TECHNICAL NOTE

File Ref: MA/CS/P21-2319/01TN

Subject: EL Dowley – Deadline 2 Submission

Figure 1: Proposed Location of 5-arm Roundabout on B1172 (source: Google Maps)

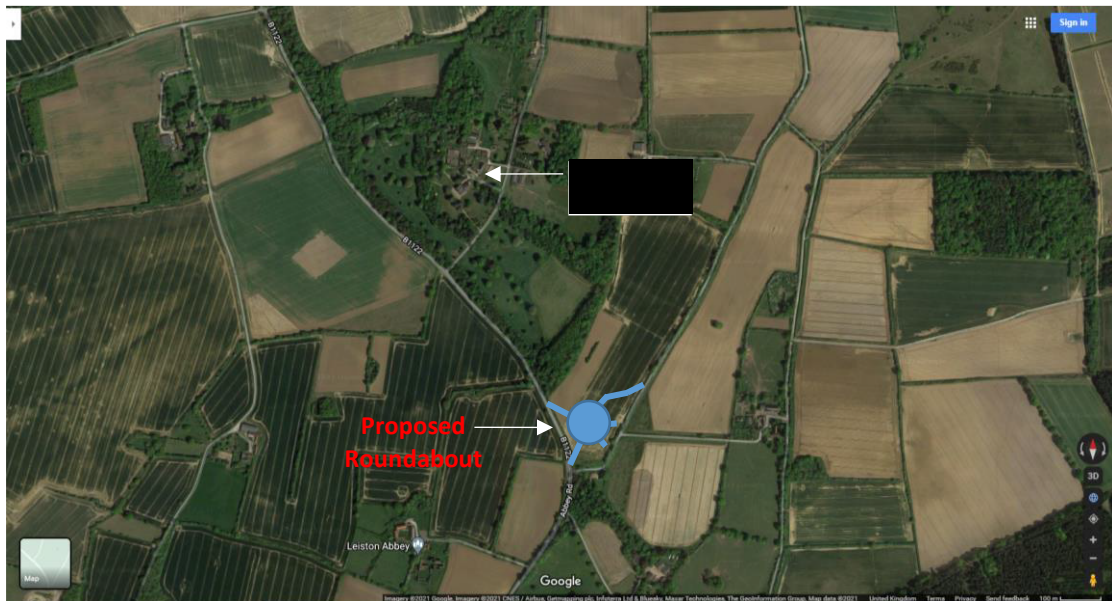
- Inconvenience/amenity;
 - Traffic capacity/safety;
 - Noise;
 - Lighting;
 - Dust; and
 - Visual impact.
- 1.4 Figure 1.1 highlights the proximity of our Client’s residential dwelling in relation to the proposed new roundabout (shown indicatively).

DRAWING TITLE:
MAIN DEVELOPMENT SITE
MAIN SITE ACCESS ROUNDABOUT
PROPOSED VERTICAL PROFILES
SHEET 5 OF 22

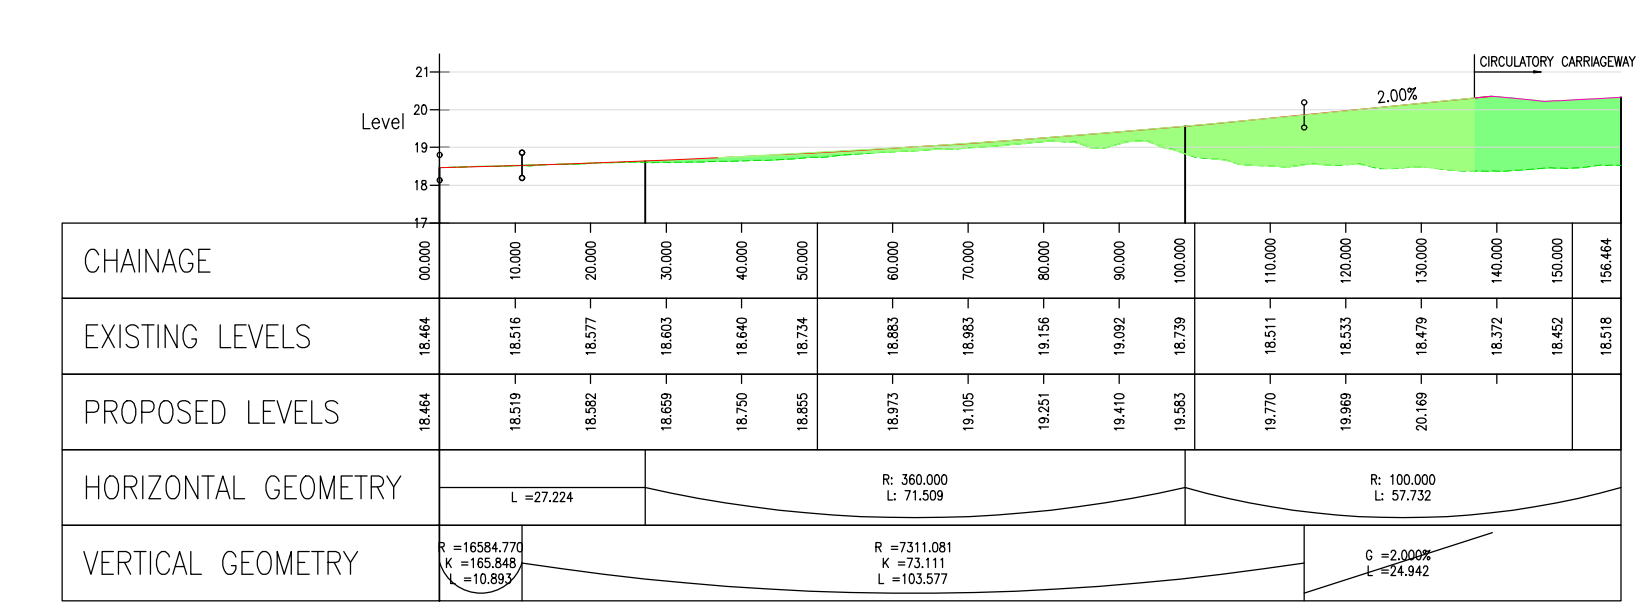
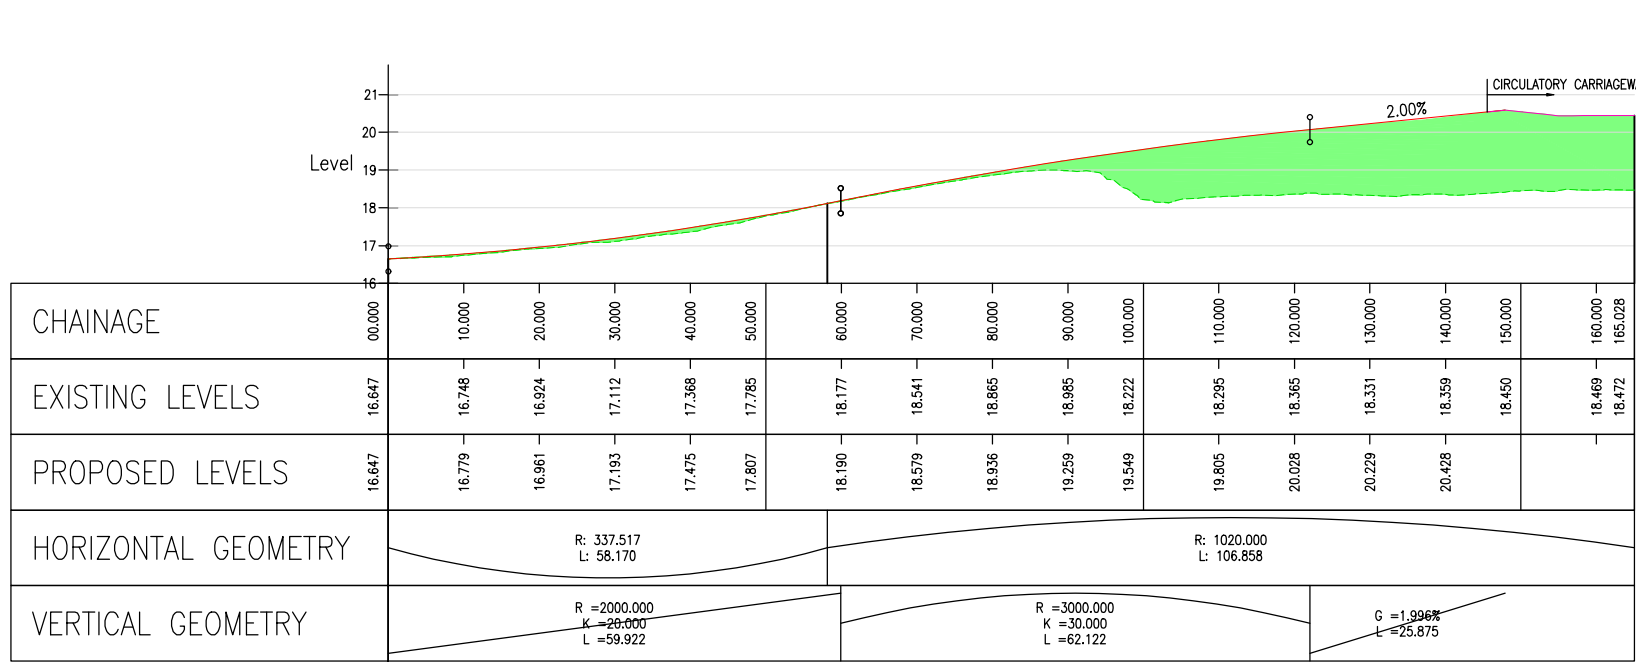
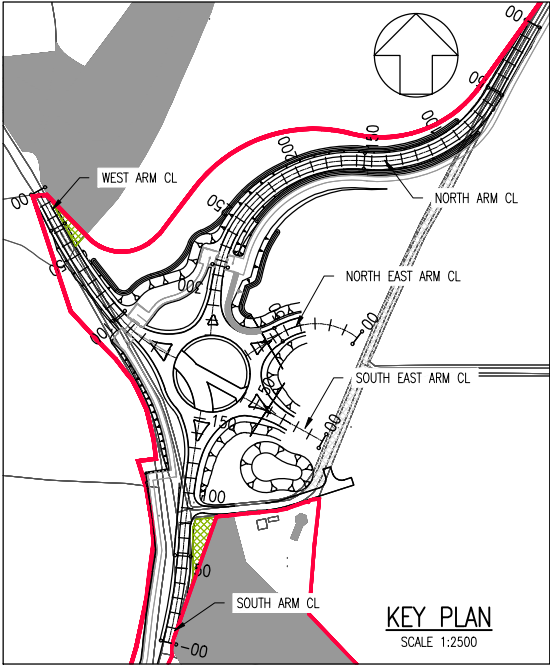
- The roundabout will be of significant scale, and in-part elevated above surrounding land according to the new embankments indicated on the scheme plans. Will there be sufficient planting and screening for the new roundabout;

- Sight stopping distances (120m) on the B1172 approaches to the proposed roundabout appear to be based on design speeds of 60kph (circa 45mph). At this location, the national speed limit (60mph) is currently in force which is significantly in excess of the applied design speeds. Consequently, visibility provision may need to be extended and this will increase the overall footprint of the junction further;

DRAWING TITLE:
MAIN DEVELOPMENT SITE
MAIN SITE ACCESS ROUNDABOUT
PROPOSED LIGHTING PLAN
SHEET 3 OF 22

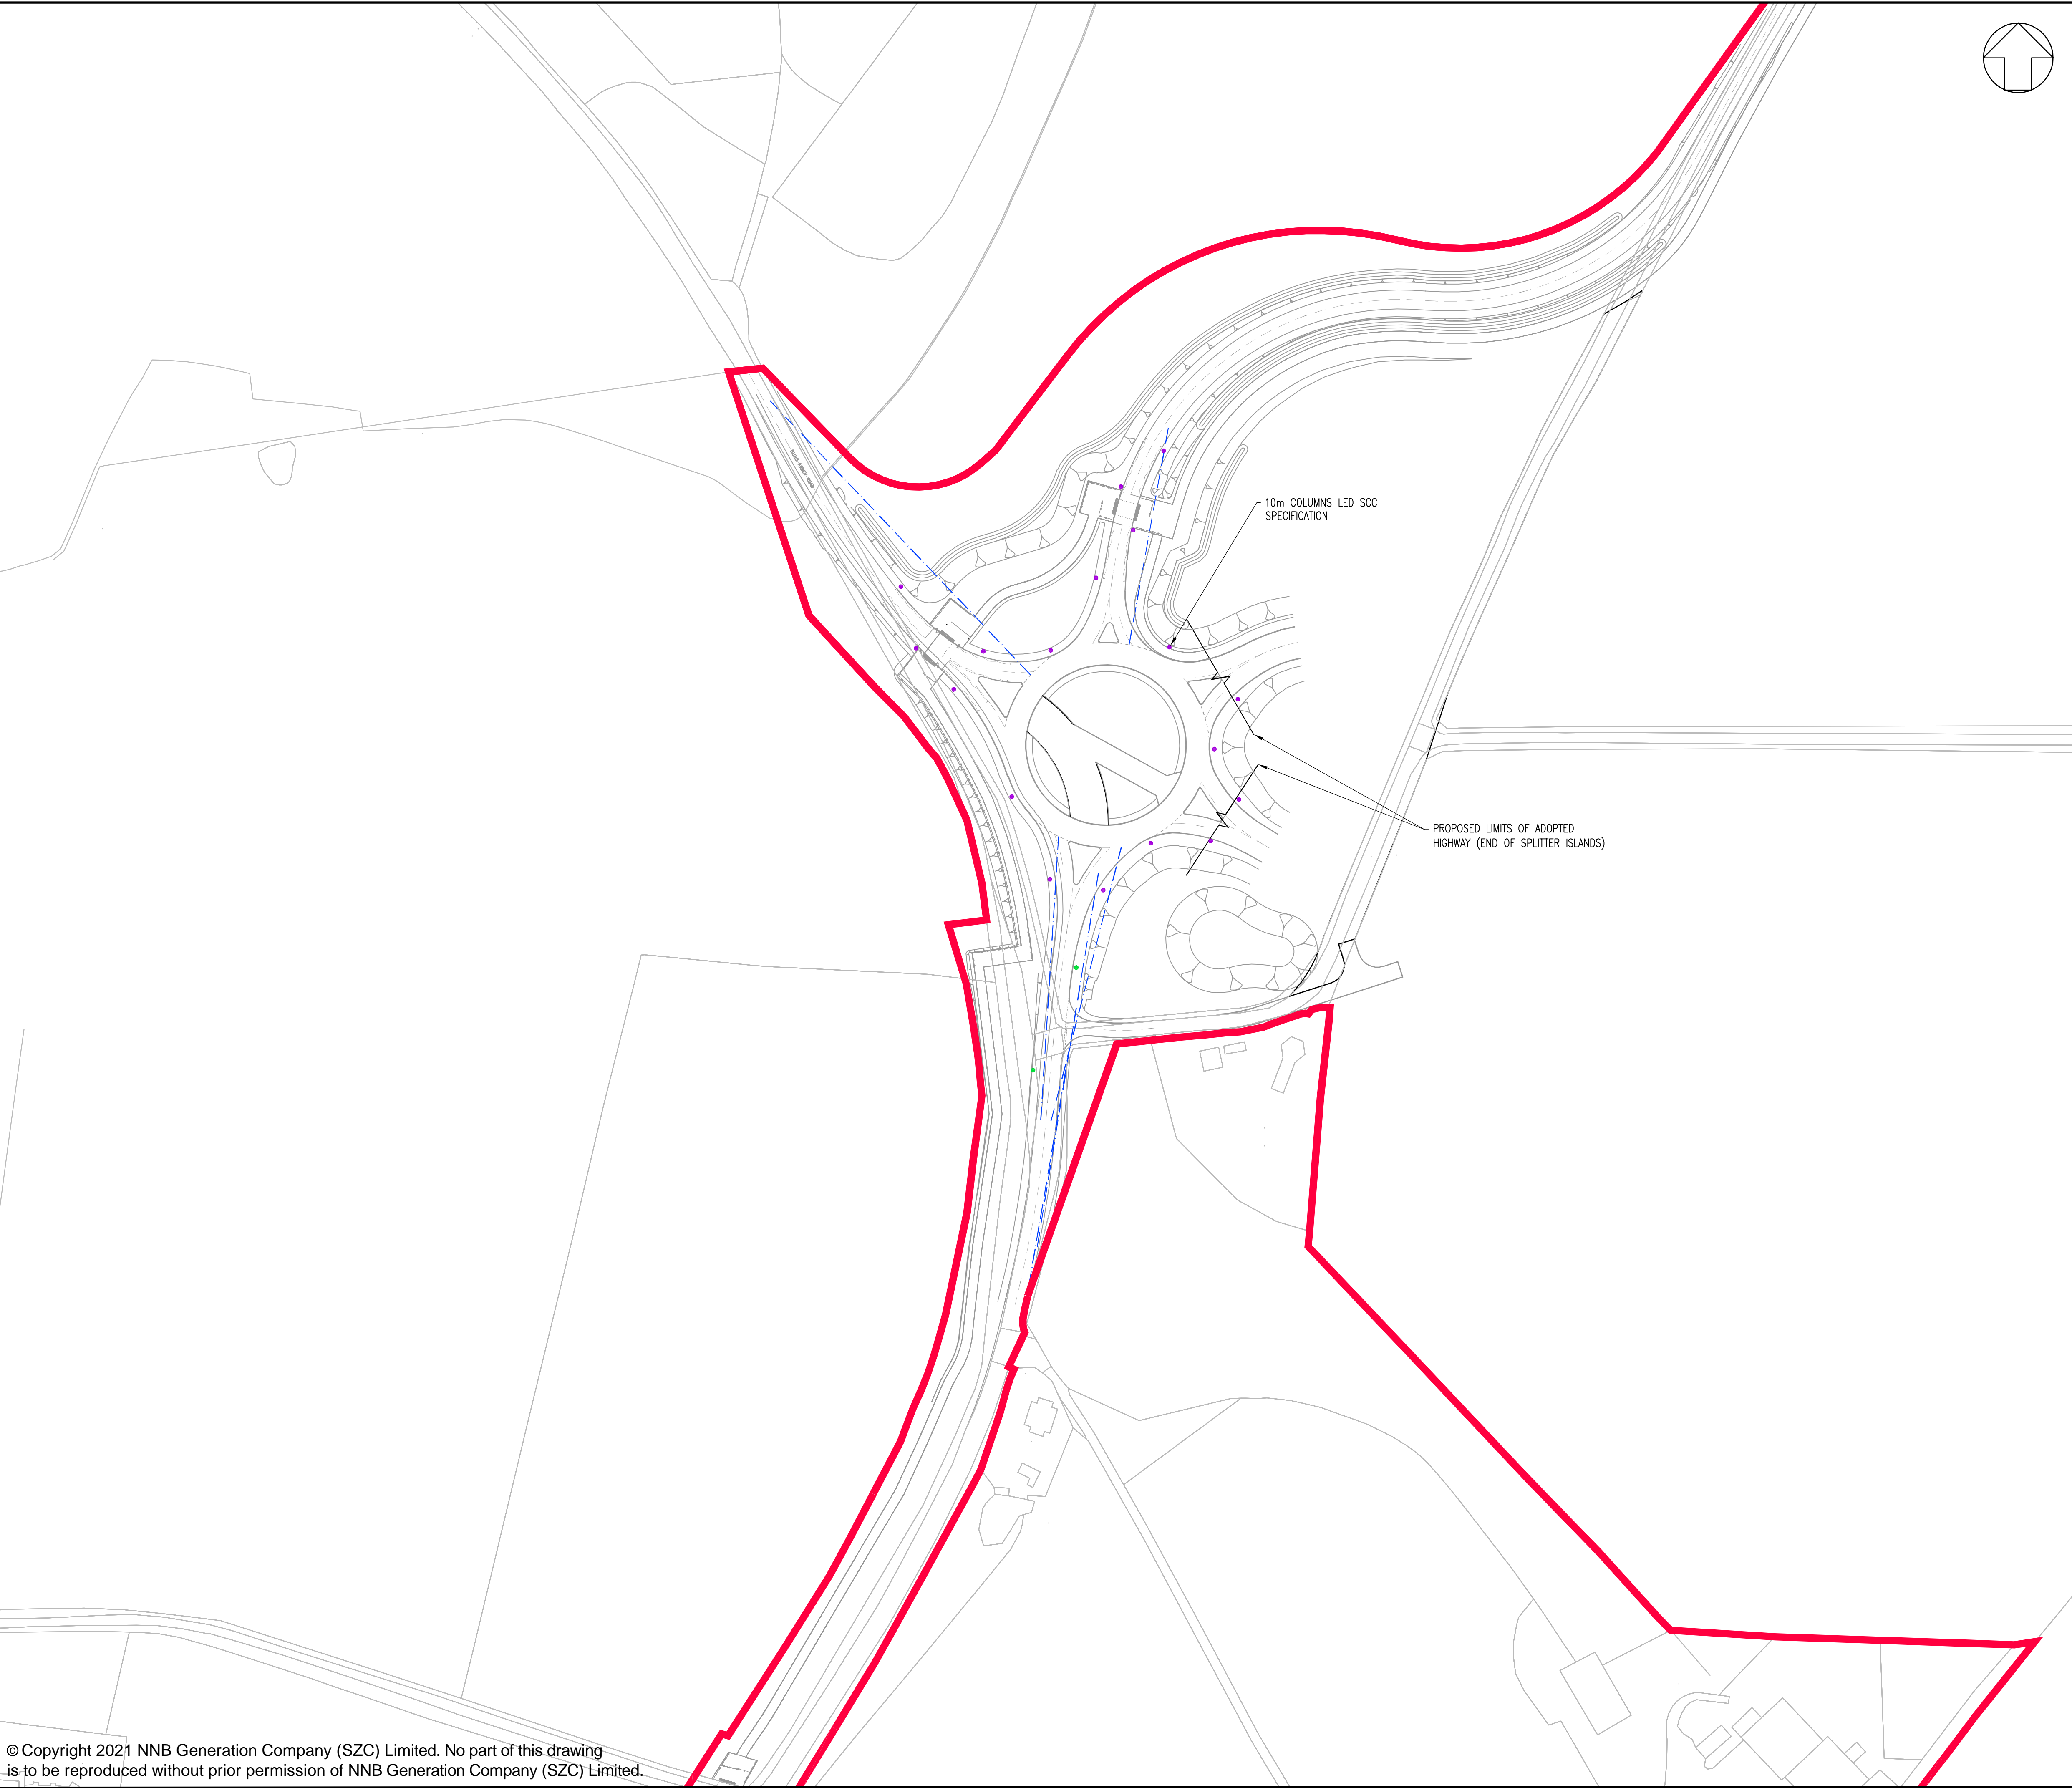
- 2.3 The large ICD of the proposed roundabout will mean that illumination will be a significant issue at this location with the junction fully lit.
- 2.4 Create have reviewed the lighting proposals and consider this will result in widespread light pollution at this rural location.
- 2.5 The case for full street lighting at this location would need to be fully justified with mitigation put in place if this is deemed necessary, no light pollution mitigation is currently proposed by

the Applicant and at present, the current scheme design put forward is not considered to be acceptable to our Clients.
